ASSESSMENT REVIEW

Review of daylight and sunlight assessments for a development at the former John Lewis depot, Crossland Road, Reading

Prepared for: Reading Borough Council
Date: 27.08.2025
Report number: P130571-1000
Issue: 1
Status: Final - Commercial

Figure 1 - Site and surrounding buildings adapted from a figure in the appendix of the GIA report.

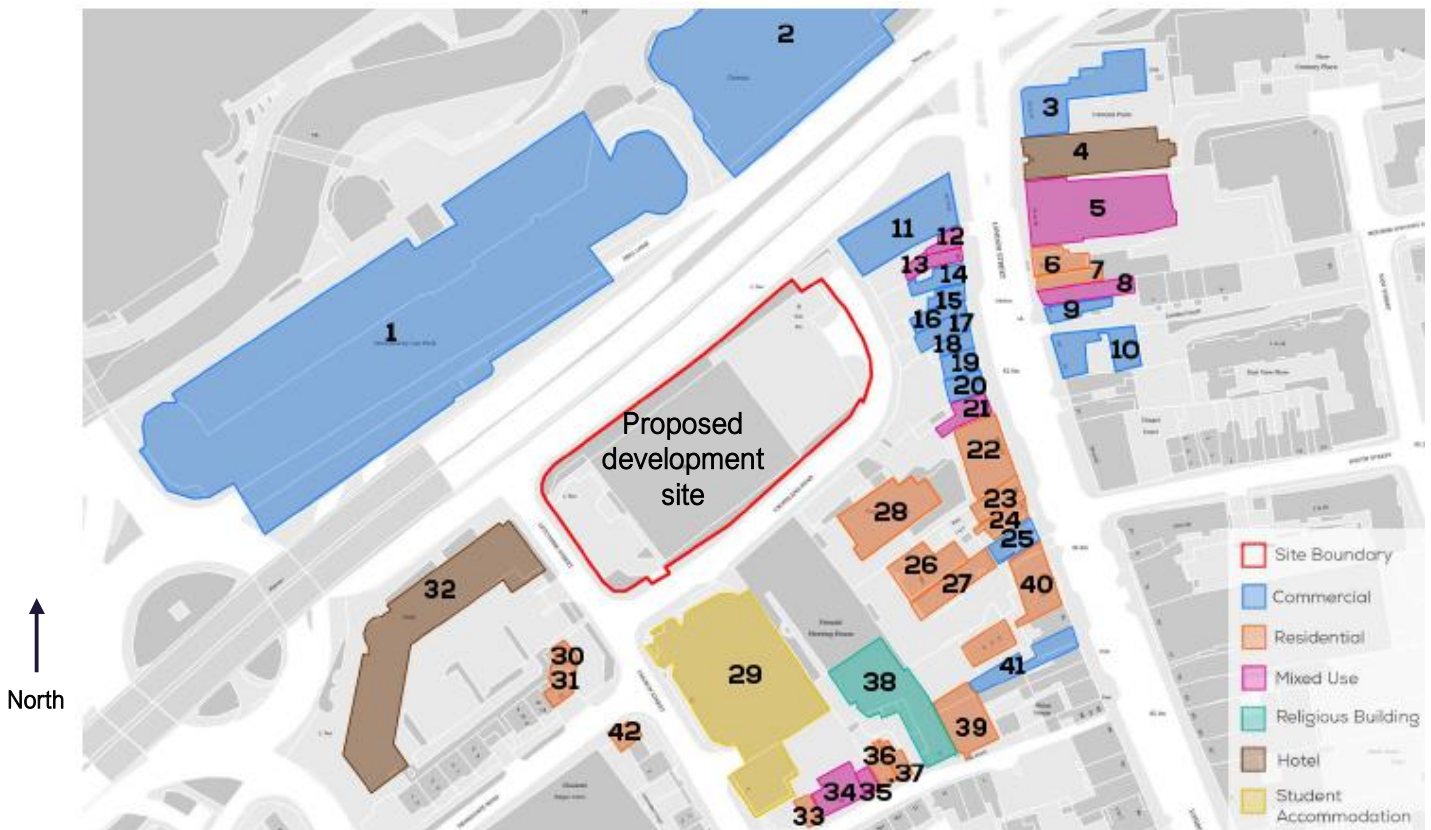
The scope of the study in terms of properties assessed appears generally appropriate, as the nearest existing buildings have been considered. However, the above figure from the GIA report does not include a key to numerical labelling of each property as shown. Window maps showing the position of windows analysed are also not included in the assessment, so it has not been possible to check these against the actual buildings. We suggest these are provided. For the purposes of this review, it is assumed that the appropriate number and position of windows at each property has been assessed.

The Premier Inn hotel to the west of the site (labelled as 32 in the GIA plan shown in Figure 1) is not included in the analysis. There would likely be a significant loss of daylight to the north east facing façade. However, since this is a hotel the loss of light could be seen as less of an issue, assuming no long-term occupation of the rooms.

The Quaker Meeting House (labelled as 38 in the GIA plan shown in Figure 1 and 2 Church Street in the appendix) appears to have been included in the analysis.

Our understanding is there is a consented scheme PL/22/1364 at 'Central Club', 36-42 London Street (labelled as 31 in the GIA plan shown in Figure 1). The development involves construction of a new building containing a community hall and residential flats. The consented scheme is between two and three storeys taller than the existing building. The scheme is not included in the GIA assessment. For existing neighbouring buildings 44 and 46 London Street (which meet the BRE guidelines with just the proposed development), there is a potential for cumulative loss of light impacts. However, depending on the location of existing windows (which cannot be established without window maps) any cumulative loss of light may be primarily due the Central Club scheme or the proposed development rather than a combination of the two schemes since windows may not have a direct view of both. There are consented rooms at the 'Central Club' scheme on the south west façade; these would face the proposed development and there is the potential for a loss or reduction in light if the consented development were to progress. The additional storeys of the Central Club scheme compared to the existing building may also reduce daylight to rooms in the proposed development on the north east façade, particularly on the lower floors at the north end.

A block of flats called Caxton House (1-16 Deansgate Road) is to the south west of the proposal site (labelled as 30 in the GIA plan shown in Figure 1). Window maps have not been provided so it has not been possible to check the position of windows analysed.

Saxon Court is student accommodation to the south of the site (labelled as 29 in the GIA plan shown in Figure 1). Window maps have not been provided, so it has not been possible to check the position of the windows included in the analysis.

Townsend House is a block of flats to the south of the site on the opposite side of Crossland Road (labelled as 28 in the GIA plan shown in Figure 1). Window maps have not been provided, so it has not been possible to check the position of the windows included in the analysis.

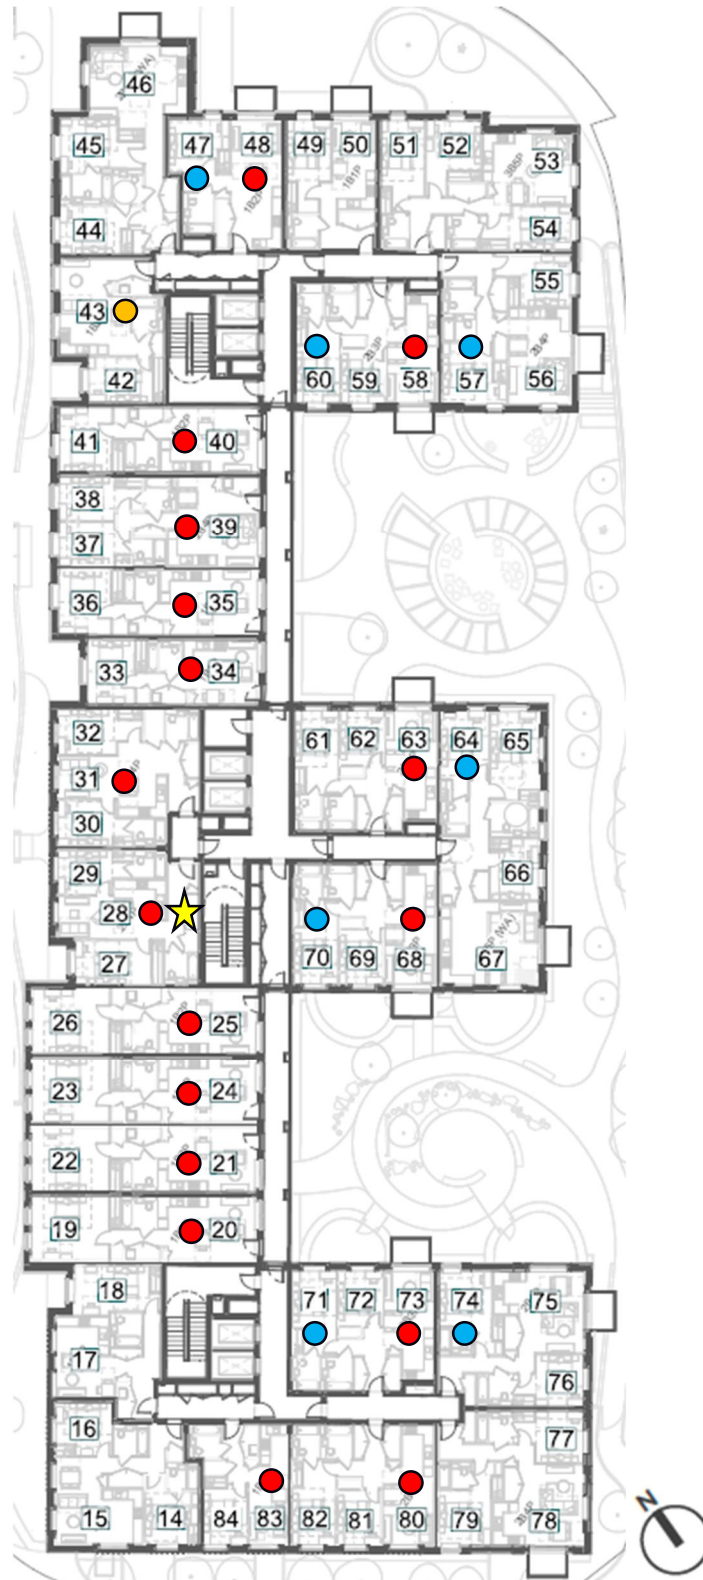
Level 1 is therefore the worst-case floor and Figure 2 below highlights the rooms on this floor below the daylight recommendations.

LKDs below the recommendations on level 1 are deep single aspect spaces. The majority are located on the south east facing façade of the development where the design and layout of the proposal, including access walkways and balconies, restricts daylight provision. The limitations on daylight in these areas are therefore due to the proposal itself, rather than the obstruction of existing surrounding buildings.

On the north-west side of the proposal the majority of rooms are bedrooms, which meet the daylight recommendations. There would be two LKDs below the living room recommendation (including a worst-case result) and a further LKD which meets the living room recommendation, but would be below the kitchen recommendation. If the Vue cinema complex site is redeveloped (currently under consideration PL/22/1917), daylight results to at least the northern tip may be reduced.
